Technical Service Information

NISSAN RL3F01A 1982-1983 STANZA/SENTRA FLARE ON 1-2 AND 2-3 SHIFTS

Figure 1

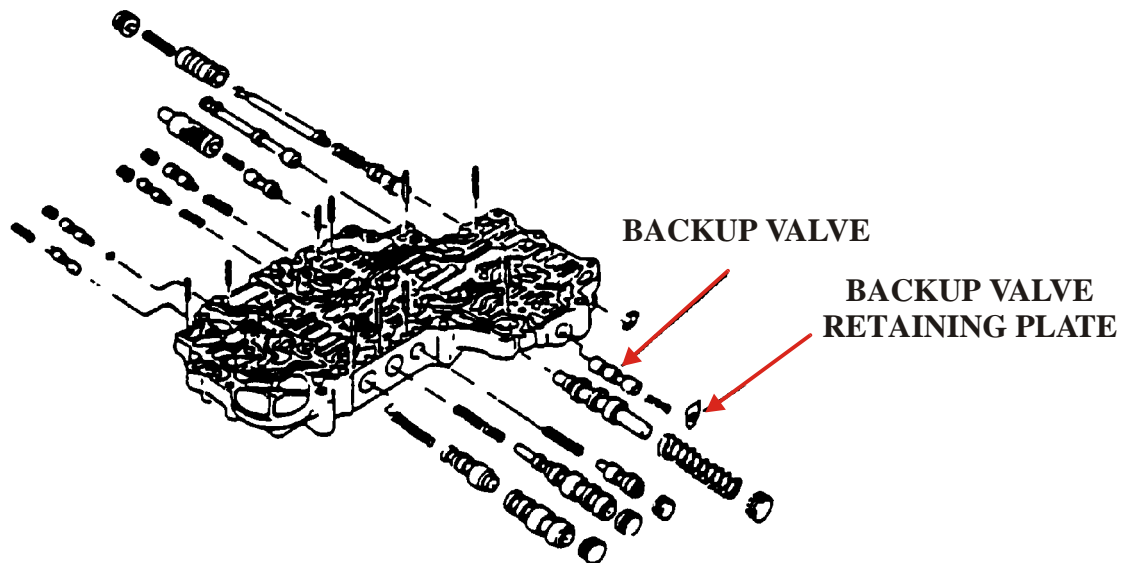
COMPLAINT: Engine flare on 1-2 and 2-3 shifts with the transmission in the drive range.

CAUSE: A broken back-up valve retaining plate.

OLD PART # 31748-01X00

CORRECTION: Install a new plate, part # 31748-01X01

NEW PART # 31748-01X01
